RE: Federal Recall Campaign 200-C
Caterpillar Engine Routing on Peterbilt trucks
Built Between December 15, 1997 and December 21, 1998
Expiration Date: None

SUBJECT: SAFETY RECALL #200-C
 CATERPILLAR ENGINE ROUTING
 EXPIRATION DATE: NONE

<p>A DIVISION OF INCOER</p>	DATE 02-10-00	DRAWN BY E.D.HUCKABY	COMPLIANCE	MANUFACTURING	MODEL CODE 7	 REV -
	RELEASE	APPROVAL M.T.GRIMM	TITLE ROUTING CIRCUIT BREAKER		DRAWING PH16-00019	
	1ST CHASSIS	FINAL APPROVAL P.F.METZLER			SHEET 1 OF 5

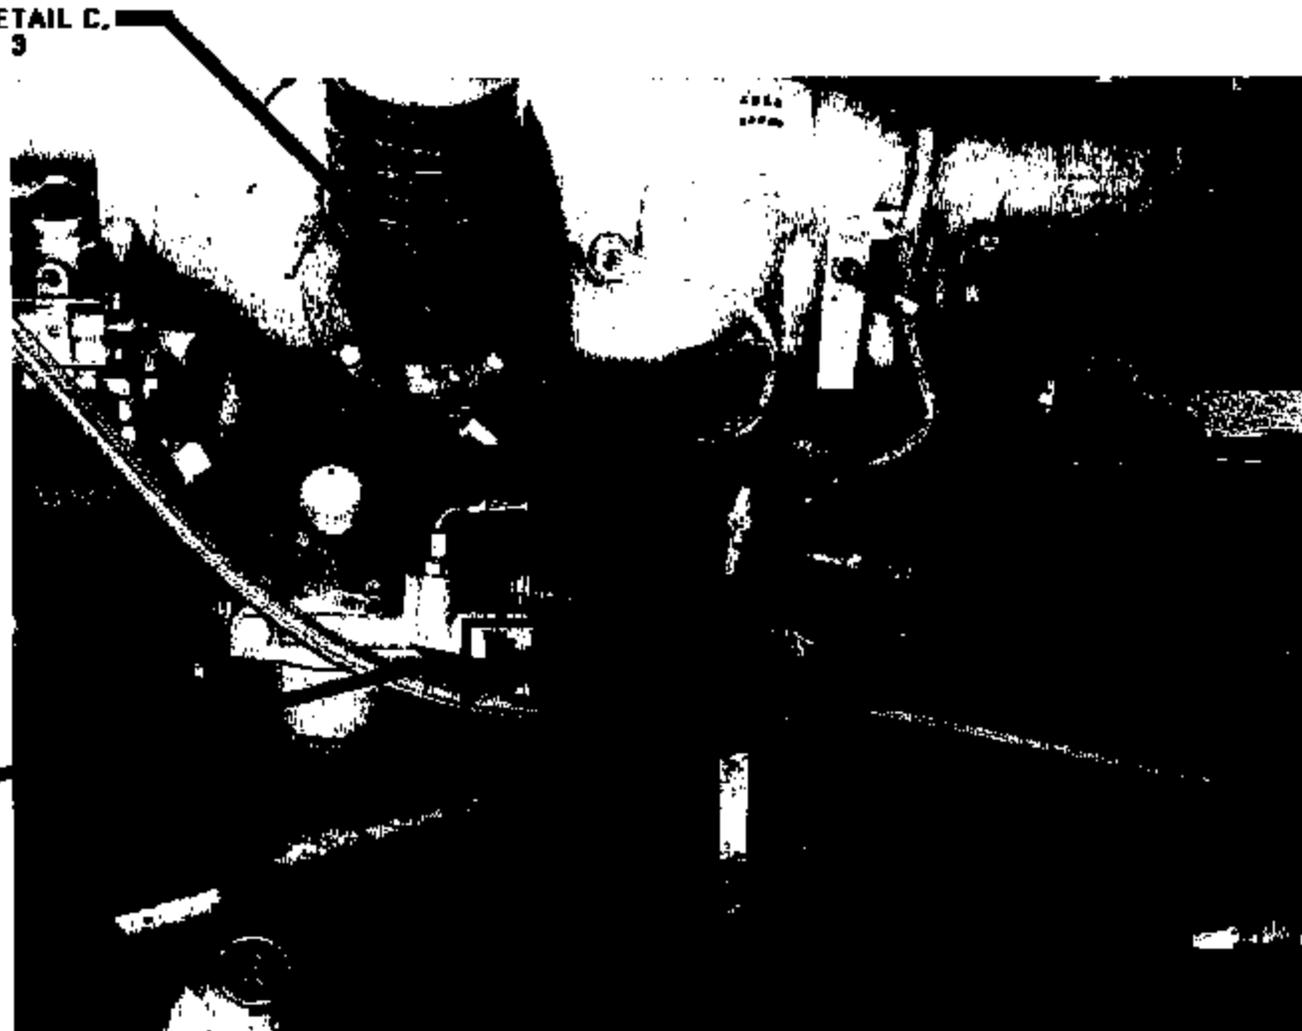
- 1) SEE SHEET 2 FOR FUEL LINE ROUTING DETAILS AND INSTRUCTIONS.
- 2) SEE SHEET 3 DETAIL D FOR SHORT JUMPER WIRE ROUTING DETAIL.
- 3) SEE SHEET 4, DETAILS E AND F FOR LONG JUMPER WIRE ROUTING DETAILS AND INSTRUCTIONS.

SEE DETAIL C, SHEET 3

SEE NOTES 2 AND 3

REVISED ROUTING

1. Drive truck into service bay and turn wheel right until contact with stop for easy access.
2. Inspect for signs of chafing (rubbing) between the Caterpillar fuel lines and the Peterbilt electrical jumpers and harnesses. Inspect near the engine ECU and the air intake pipes on the left side of the engine (see drawing PH16-00019 for area of concern).

6. With the fuel lines and electrical wires in good condition, route electrical harnesses, jumpers and fuel lines as shown in drawing PH16-00019.
 - A. If filtered fuel return line and/or filtered supply line is routed behind engine harness alternator jumper as shown in Detail A on drawing PH16-00019 sheet 2, reroute both fuel lines so they are in front of the engine harness and secure with (2) 22-01265 tie straps as shown in Detail B on drawing PH16-00019 sheet 2.

DATE 02-10-00	DRAWN BY E.D.HUCKABY	COMPLIANCE	MANUFACTURING	MODEL CODE 7	
RELEASE	APPROVAL M.T.GRIMM	TITLE ROUTING, CIRCUIT BREAKER	DRAWING PH16-00019	REV -	
1ST CHASSIS	FINAL APPROVAL P.F.METZLER	SHEET 2 OF 5	FORMAT: JPE8

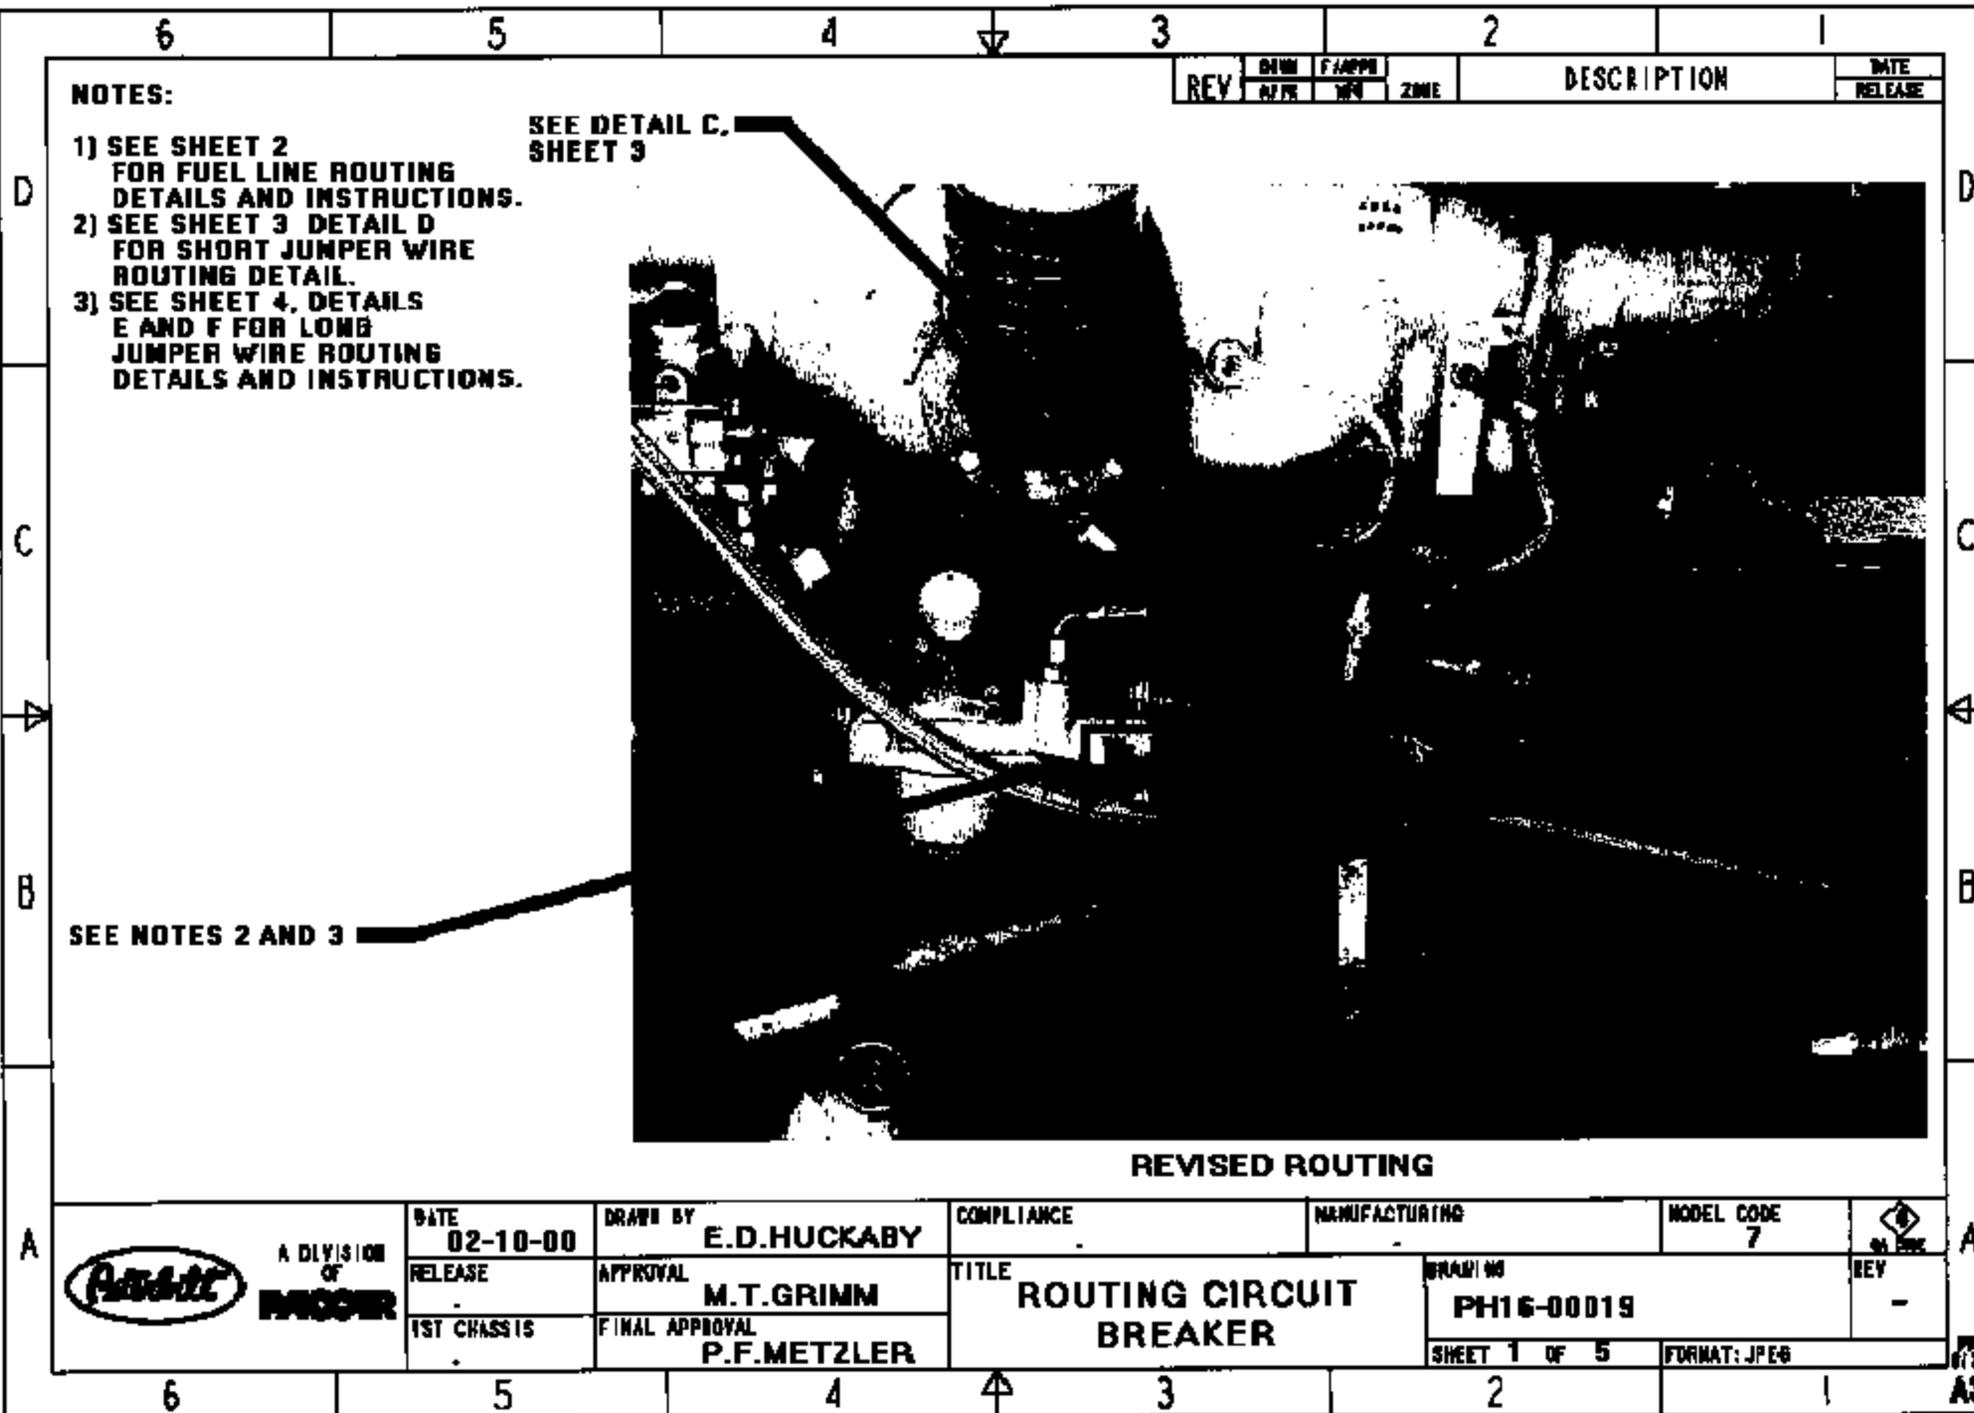
**FILTERED FUEL RETURN
LINE AND FILTERED SUPPLY
LINE SHOWN ROUTED BEHIND
ALTERNATOR JUMPER WIRE.**

**DETAIL A
BEFORE**

**DETAIL B
AFTER**

**REROUTE FILTERED FUEL RETURN
LINE AND FILTERED SUPPLY LINE
IN FRONT OF ENGINE HARNESS AND
SECURE WITH (2) 22-01265 TIE STRAP
AS SHOWN.**

**ENSURE 0.25" CLEARANCE BETWEEN
ENGINE HARNESS AND FUEL HOSES**
